ADDENDUM NUMBER 1

EVENT CENTER PARKING LOT EXPANSION @ VICTOR VALLEY COLLEGE

VICTOR VALLEY COMMUNITY COLLEGE DISTRICT

September 8, 2025

HORIZONTAL CONTROL PLAN

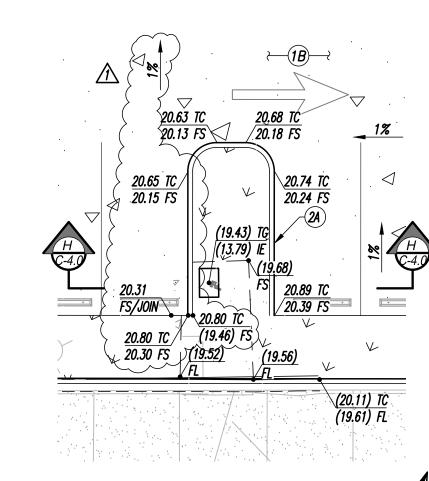
Item Number 4: Remove sheet C-2.0 - Horizontal Control Plan and replace with attached sheet C-2.0, clouded with delta-1. The following changes were made:

A. PCC join limits revised to depict limits of new PCC

PRECISE GRADING PLAN

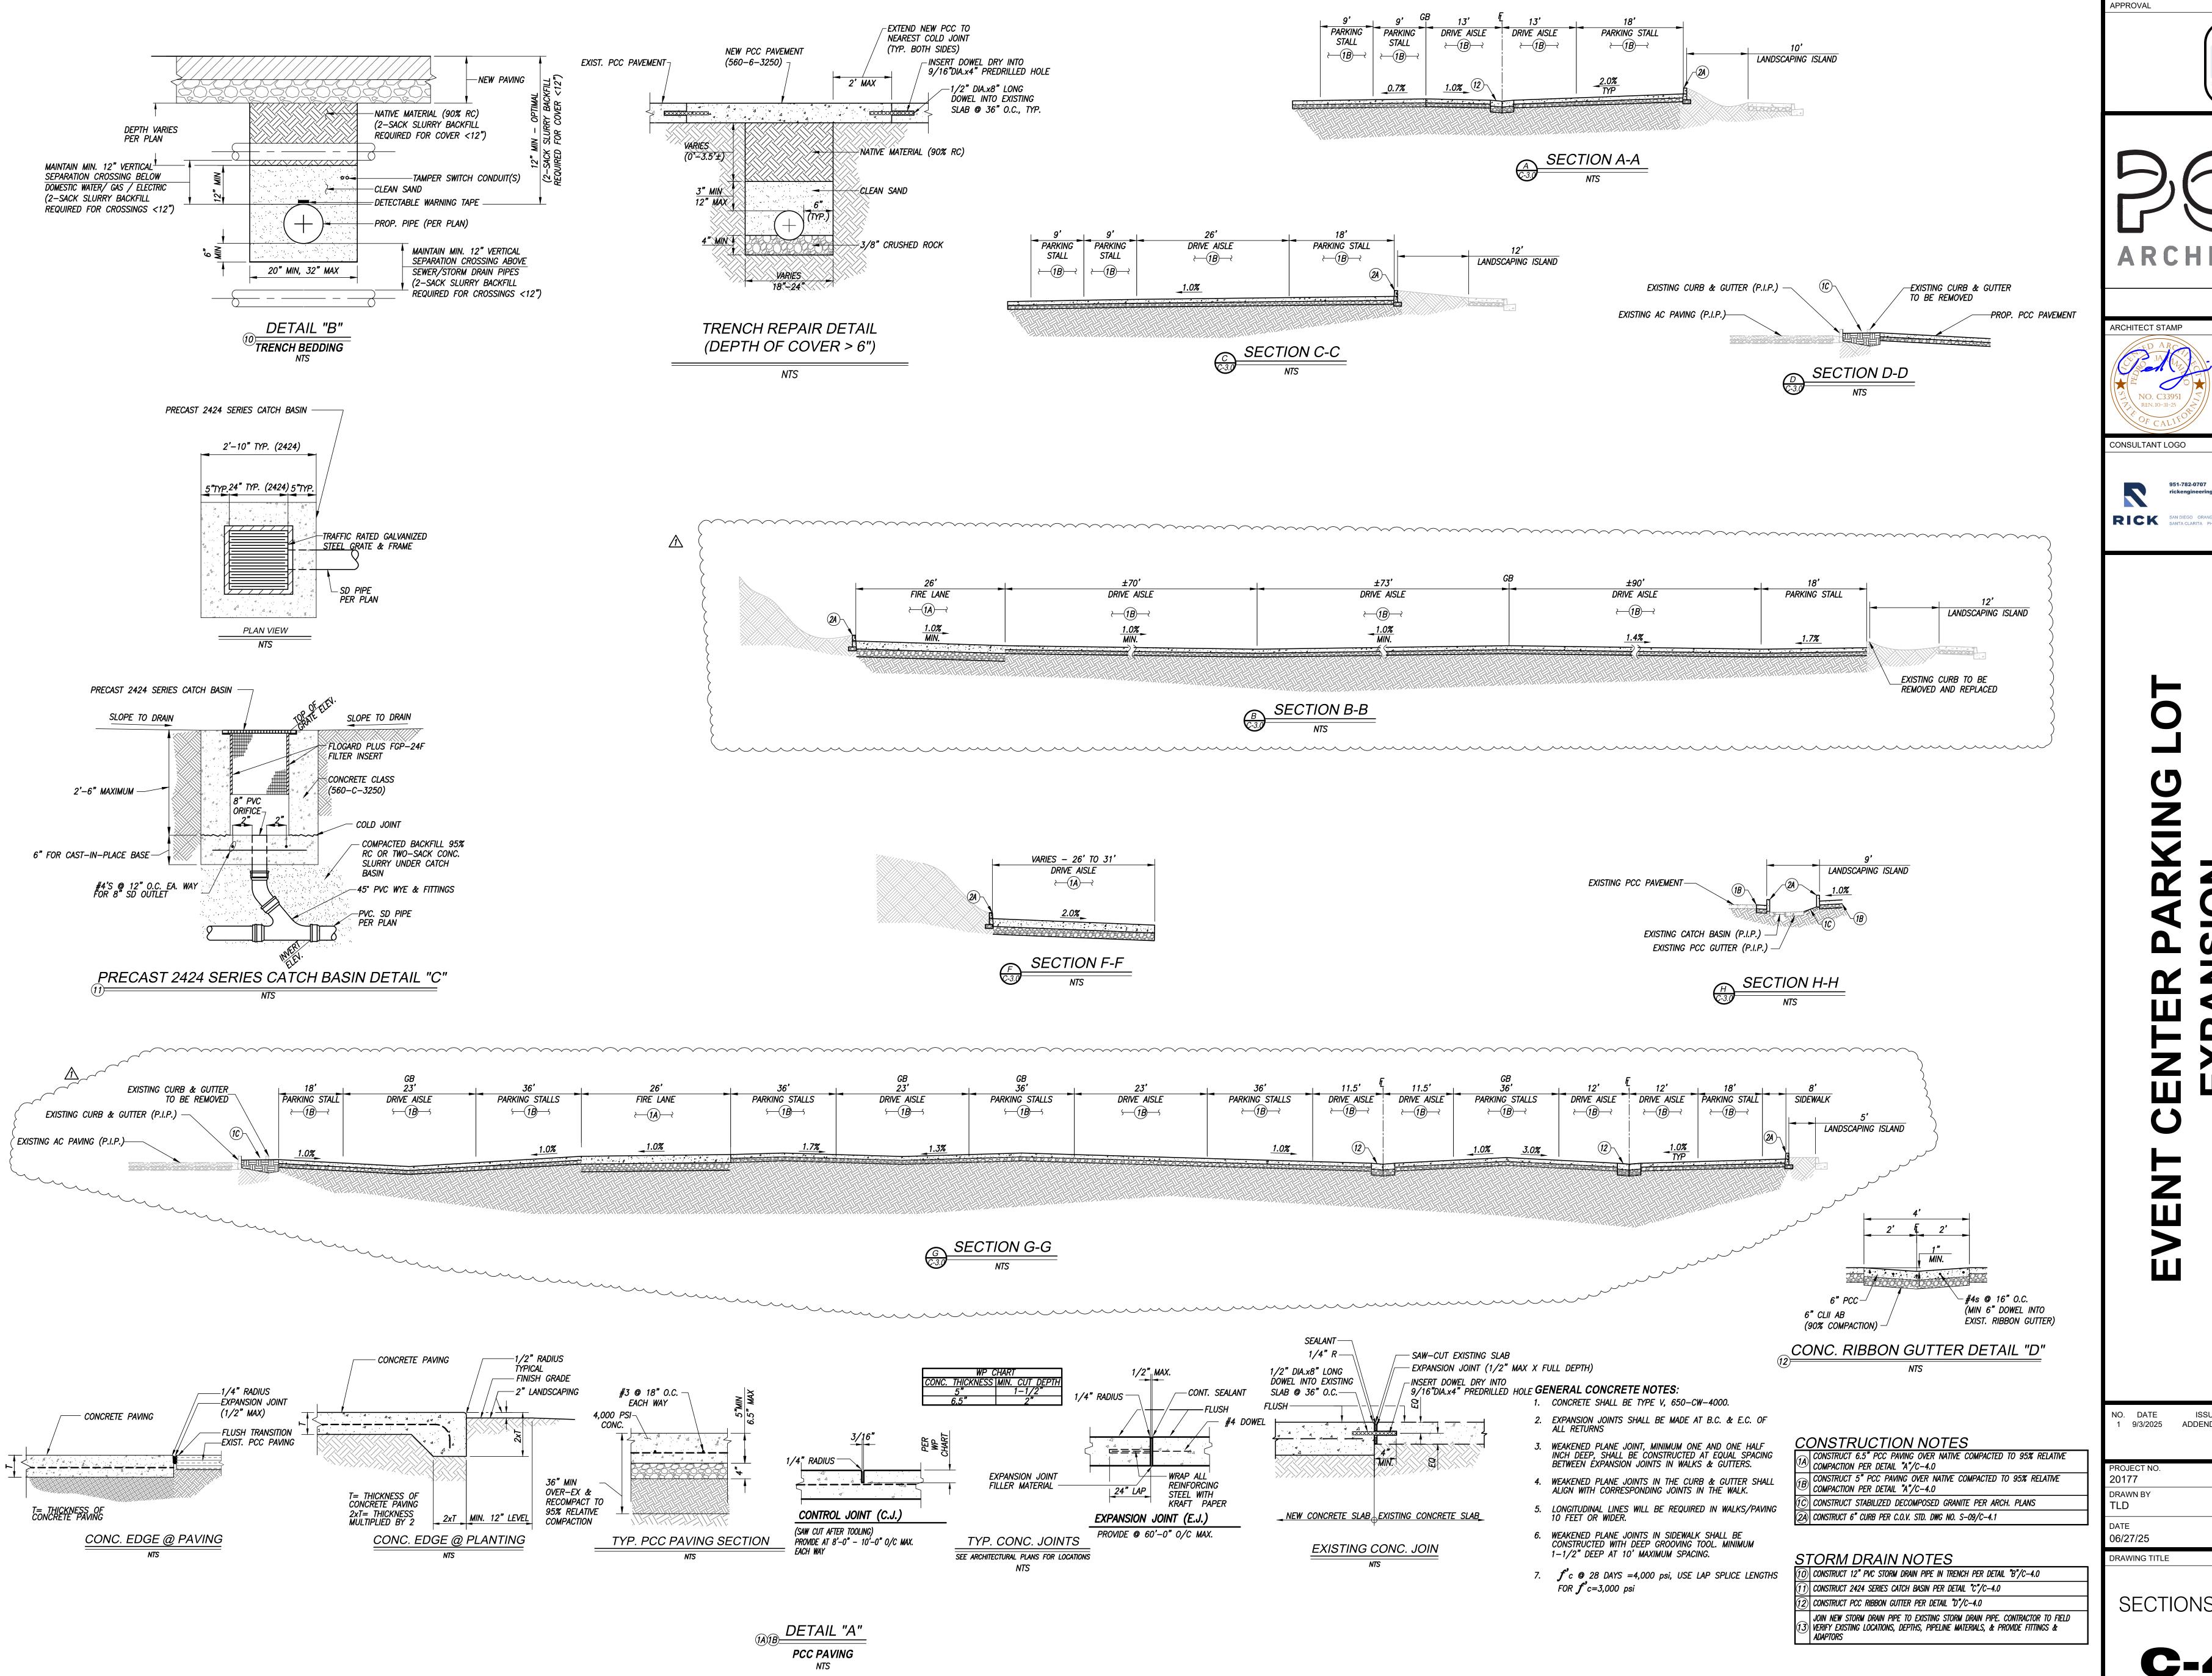
Item Number 5: Remove sheet C-3.0 - Precise Grading Plan and replace with attached sheet C-3.0, clouded with delta-1. The following changes were made:

- A. Existing parking lot previously protected in place now being removed and replaced with new PCC pavement.
- B. Grade callouts, hatching and notes revised accordingly.
- C. Added grade callouts to all four corners of landscaping islands.
- D. Removed C.N. #4, shifted C.N.s #5, 6, 7, and 8 down one respectively. In other words, C.N. #5, 6, 7, and 8 are now #4, 5, 6, and 7.
